APPENDIX E
Provincial Peer Review Comment Record

Provincial Peer Review Comments: Centre Wellington Tier Three Water Budget, Physical Characterization Report

APPENDIX F
Local Knowledge Peer Review Comment Record

APPENDIX G
Community Liaison Group Comment Record

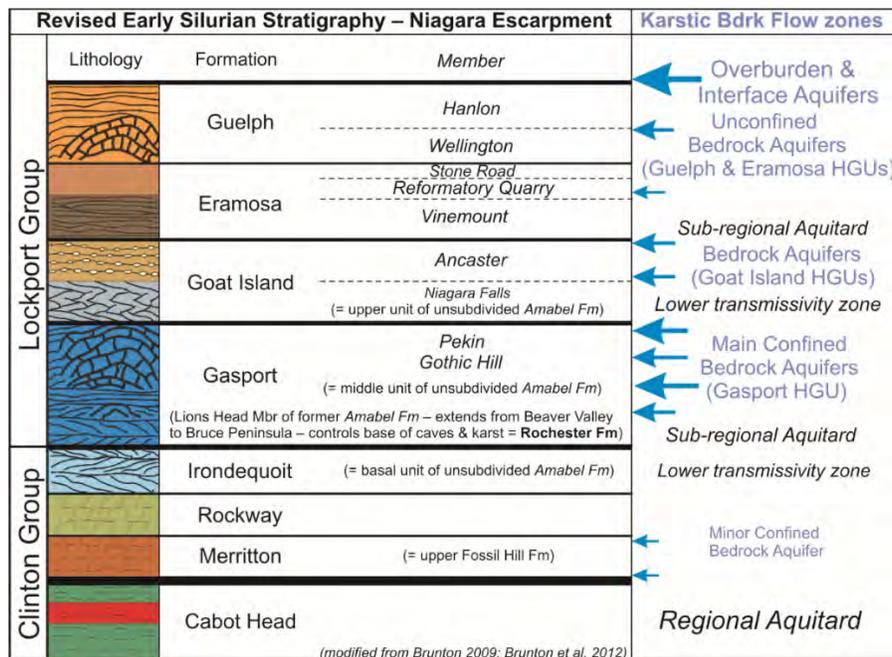
It would be helpful to see a figure that shows which wells were used to derive the overburden aquifers and aquitards vs the bedrock aquifers and aquitards. I have summarized what criteria were used to create the delineation of predominantly karstic flow zones in Silurian dolostones of Niagara Escarpment in a number of papers in numerous talks since 2009 (see Figure 1 below).

Figure. 2. Location of key wells in study area that have a variety of borehole-based geological and/or hydrogeological data.

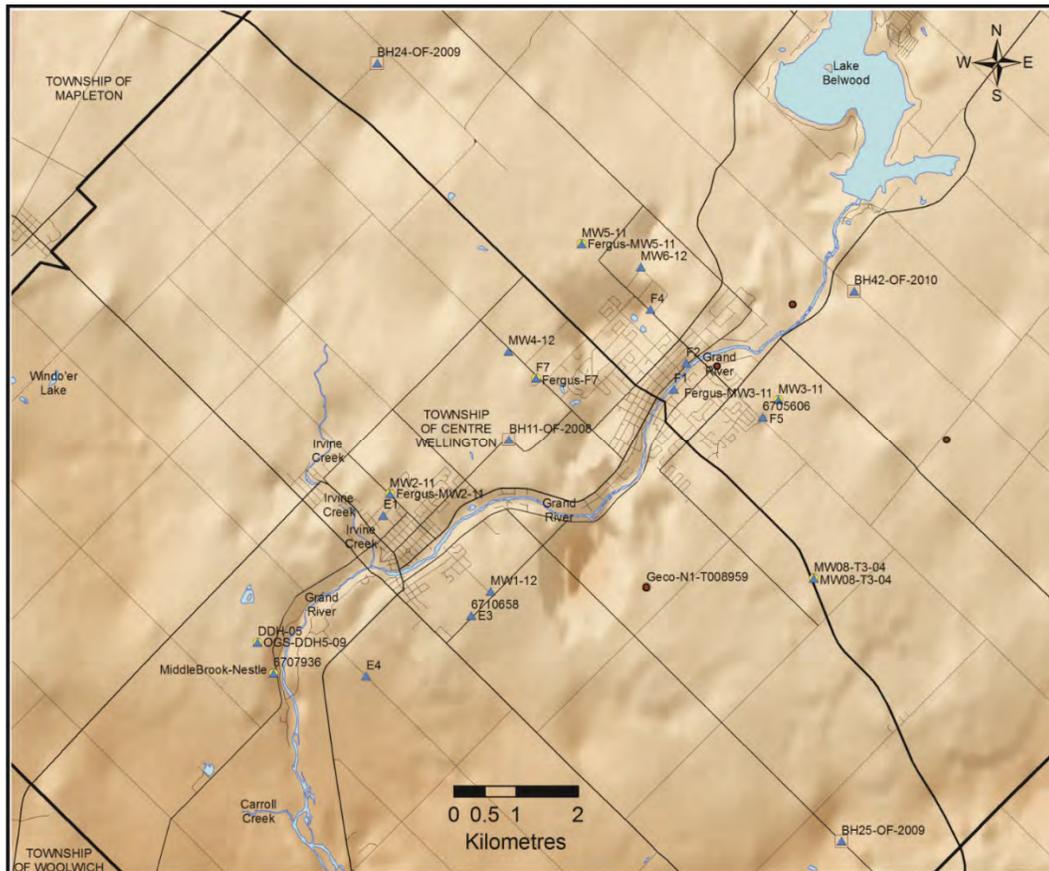
Karstic flow conditions in many of reports for Centre Wellington are described from upper Guelph and/or deeper Goat Island Fm strata and some Gasport Fm stratal intervals. I believe a more thorough summary of the flow profile data and pumping test results from the key reports may help with discussion concerning from where (what depths and strat units) the majority of groundwaters are derived that are pumped from various wells (see main wells in Figure 2).

It would be advantageous to see a more detailed discussion regarding from which wells the 4100 water level elevations were derived (see figure 8 of Matrix report – shows similar well locations to those in Figure 2 below; and info in Figs 7-10). It would be helpful to see how the 10m of groundwater elevation uncertainty was derived.

Karst features in televiewer logs for Centre-Wellington BHs

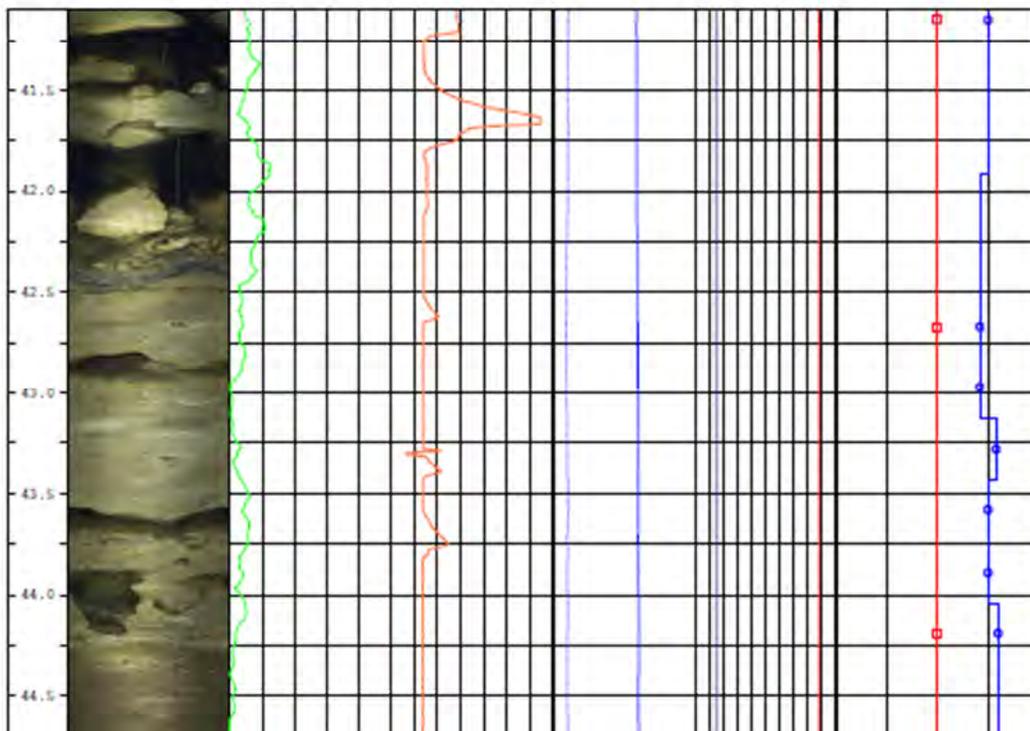
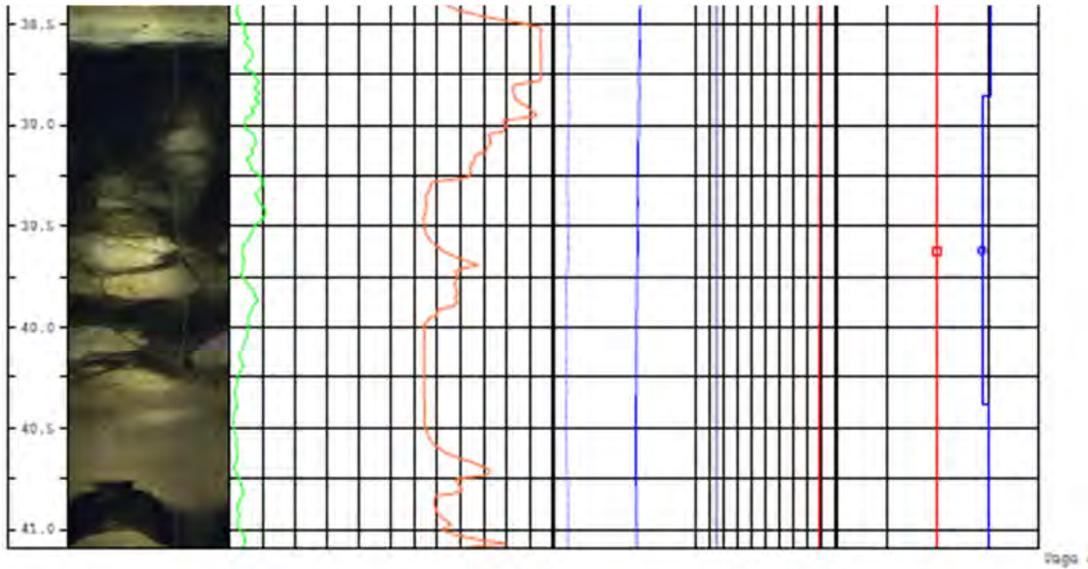
OGSDDH5-09; upper karstic intervals Guelph Fm – 38.6 m to 44.25mbgs. This is not a solution-enhanced fracture that resulted from pumping of municipal wells – as suggested in Matrix Draft report!

Figure 2. Conceptual groundwater inflows and outflows for the Study Area

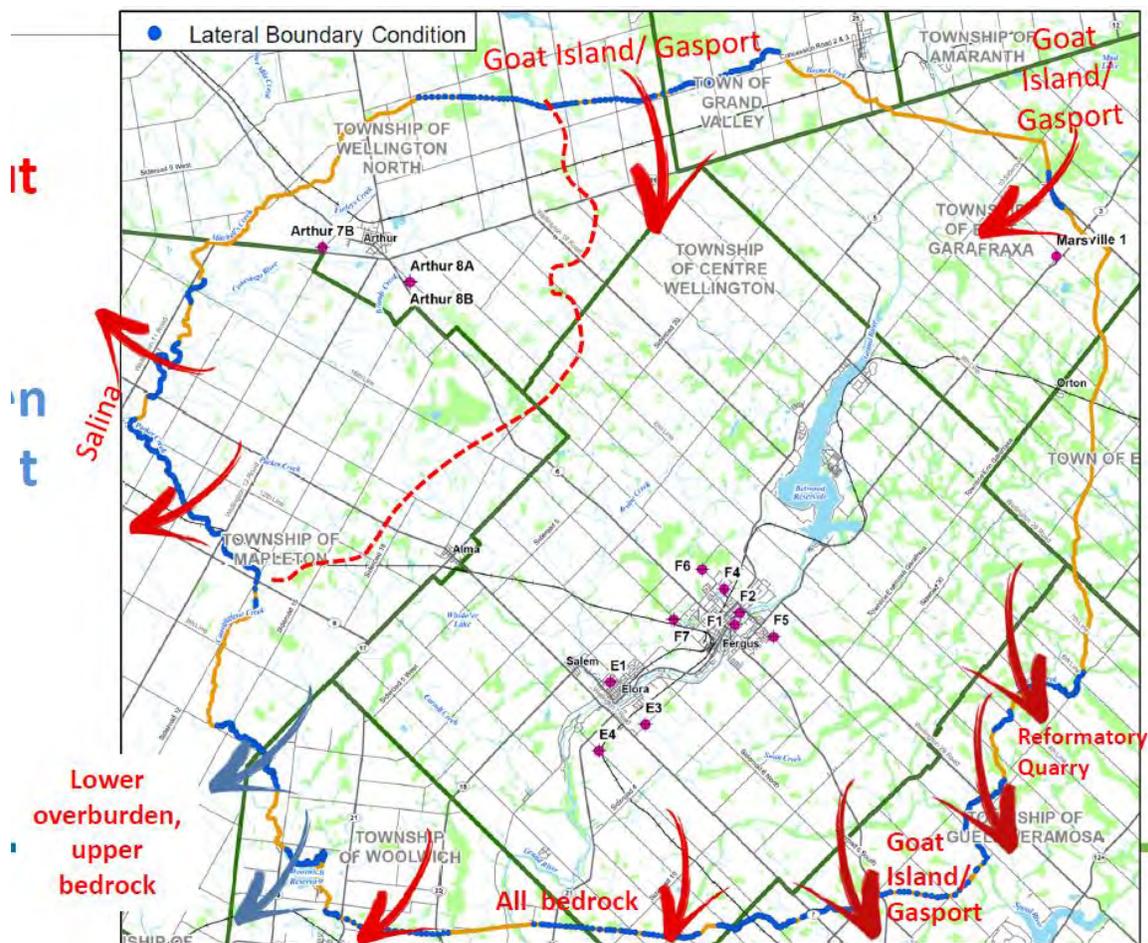
As indicated in the previous comment, only the overall simulated groundwater budget is presented, and this serves only to confirm that there is overall consistency between groundwater inflows and outflows. To be genuinely useful, the reporting of the modeling should attach magnitudes to the flows indicated in the conceptual model reproduced here in Figure 2.

- We recommend that that discussion of the overall groundwater budget be expanded to confirm that the budget is consistent with the results presented elsewhere in the report.

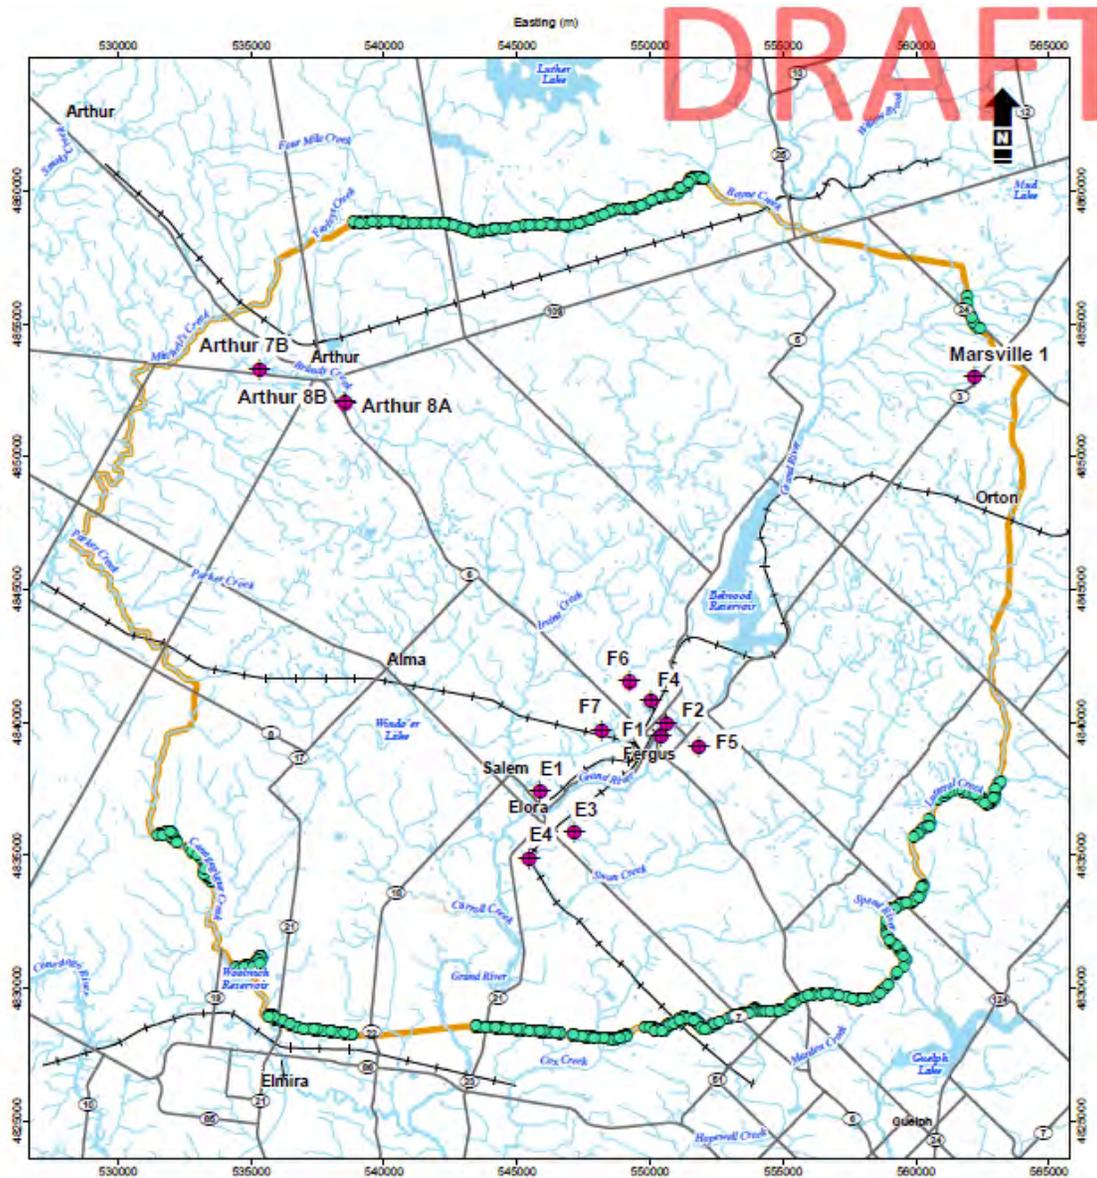
The map of the boundary conditions for the Lower Bedrock Aquifer is reproduced below from Figure 5 of the report. The green circles denote sections along the perimeter of the model along which the groundwater levels are specified, thus allowing water to enter or leave the model area from areas outside the model. As shown in the figure, these sections are relatively long.

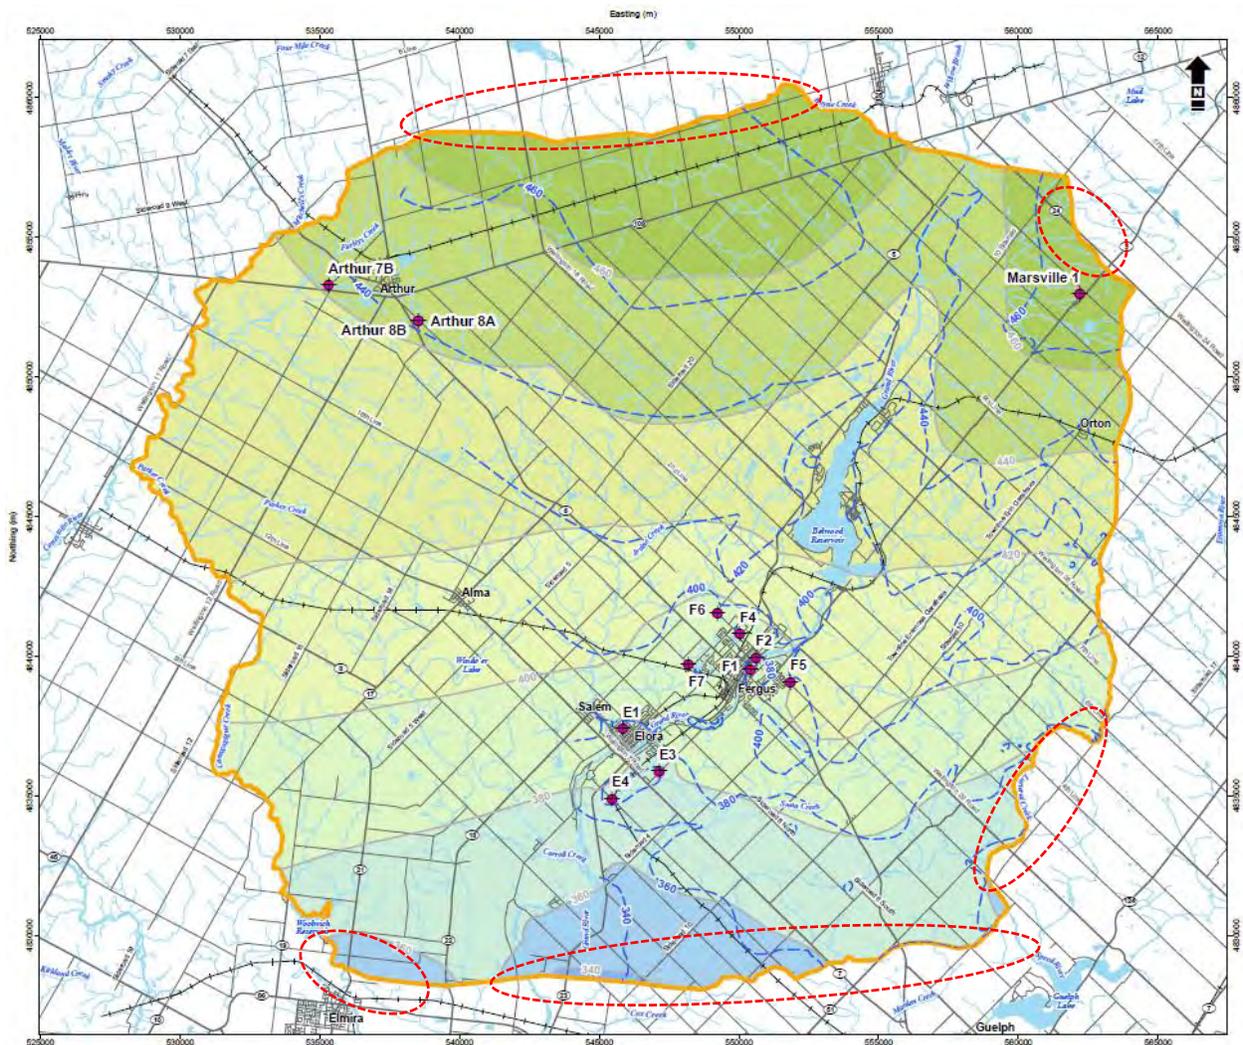
The map of the calculated groundwater levels in the Lower Bedrock Aquifer is reproduced from Figure 18 of the report. The red ellipses identify the sections of specified groundwater levels. The spacings of the contours suggest that the flow across the model area is relatively uniform. At first glance, it appears that the inflows and outflows must be correspondingly relatively large. However, referring to Table 8, the *total* cross-boundary flows comprise only a small portion of the water budget (2 mm/140 mm for inflows and 11 mm/140 mm for outflows). This does not appear to be consistent with the clear, general north to south flow patterns shown in Figure 18. Are the lateral flows into and out of the Lower Bedrock Aquifer really that small?

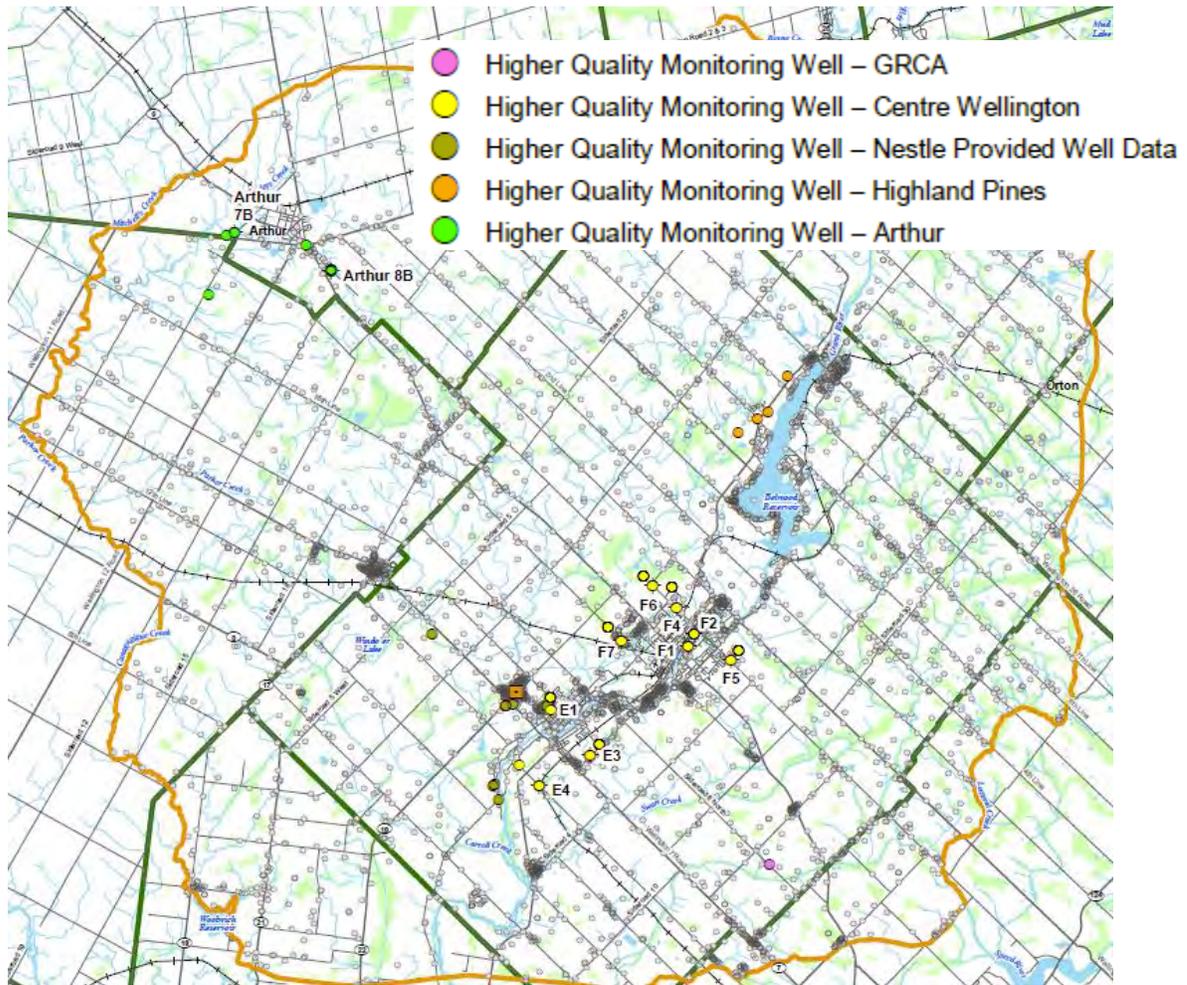
The match to the water levels from the high-quality targets is shown in format in Figure 10. A different format is adopted in Figure 11 to illustrate the match to all of the calibration targets. Goodness-of-fit statistics are reported on Page 27 of the report, but it is not indicated whether the statistics apply to the high-quality or low-quality targets.

Referring to Figure 10, are the simulated levels on average higher or lower than the targets? In the case of the pumping wells, it is clear that the observed water levels vary over relatively wide ranges. In the case of well F4, the reported range in the observed water levels is from about 353 m asl to 424 m asl, a range of **71 m**. Is it possible that the levels shown for all of the municipal production wells might represent the full ranges of water levels under *both* pumping and non-pumping conditions? Does this make sense considering that the simulation is supposed to be representative of steady-state conditions?

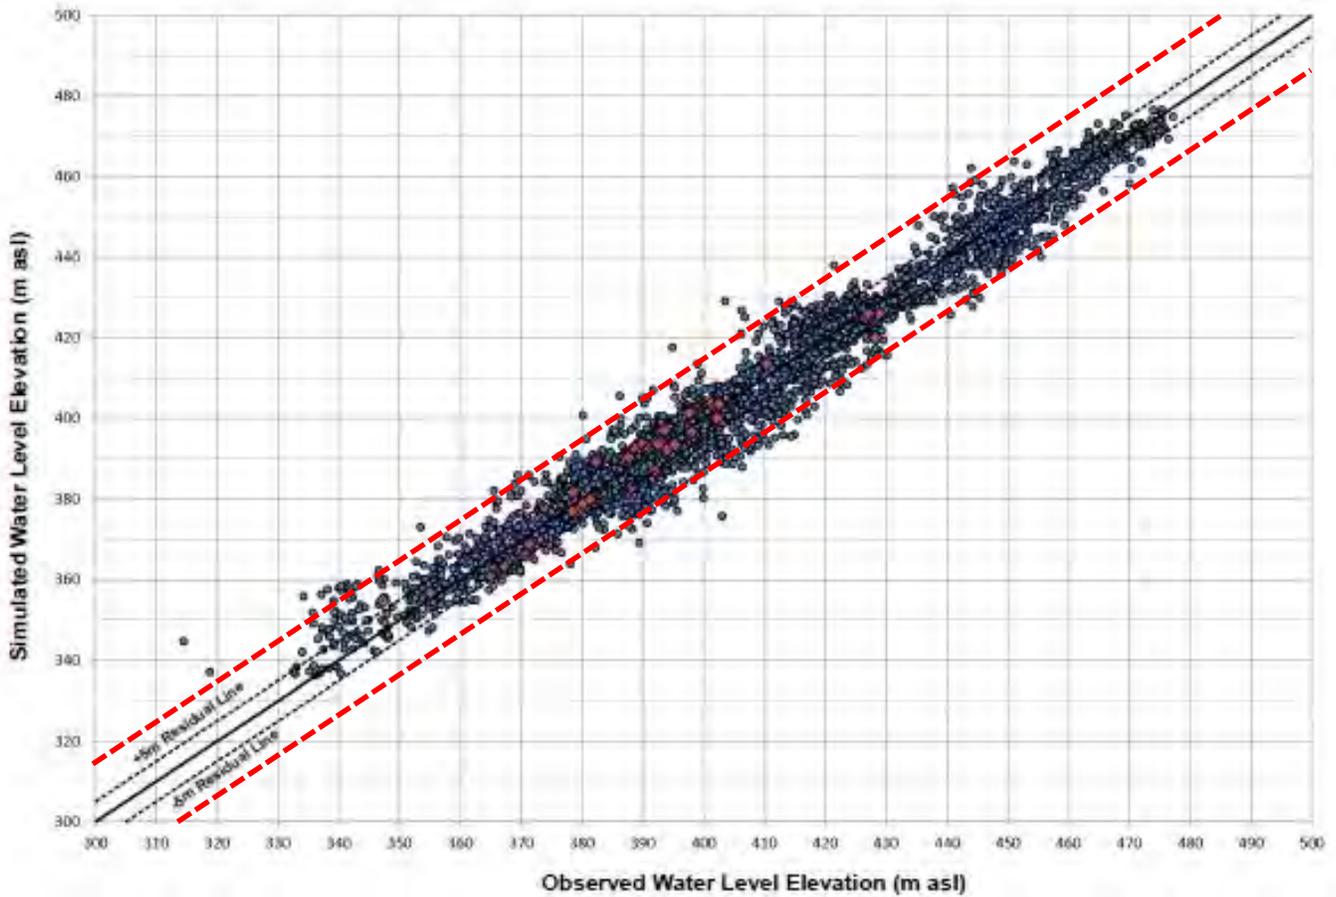
The map showing the locations of targets for the model calibration is reproduced from Figure 8 of the report. As shown in the figure, the high-quality targets are concentrated around the Fergus and Elora municipal wells. There are no high-quality targets over much of the Study Area. It is indicated that the model developed by Golder (2013) was considered for use in this project but was not applied because of the advances made to the overburden and bedrock conceptual geologic and hydrostratigraphic models in this area since completion of the Golder (2013) report. What new hydrogeologic data are available since 2013 to update the characterization of the groundwater system? What new wells have been drilled, logged, and equipped for continuous water level measurements?

The well records for private domestic wells cover the Study Area. However, the limitations of the information from these records are evident from Figure 11 of the report. Bands of model mismatch of ± 5 m are shown in Figure 11. In our opinion, these bands are much too narrow to provide a sense of how reliable the water level might be at a specific location. As indicated by the dashed red lines that have been added below, bounds of ± 15 m provide more realistic impressions of the differences between the model results and the water levels reported in the water well records.
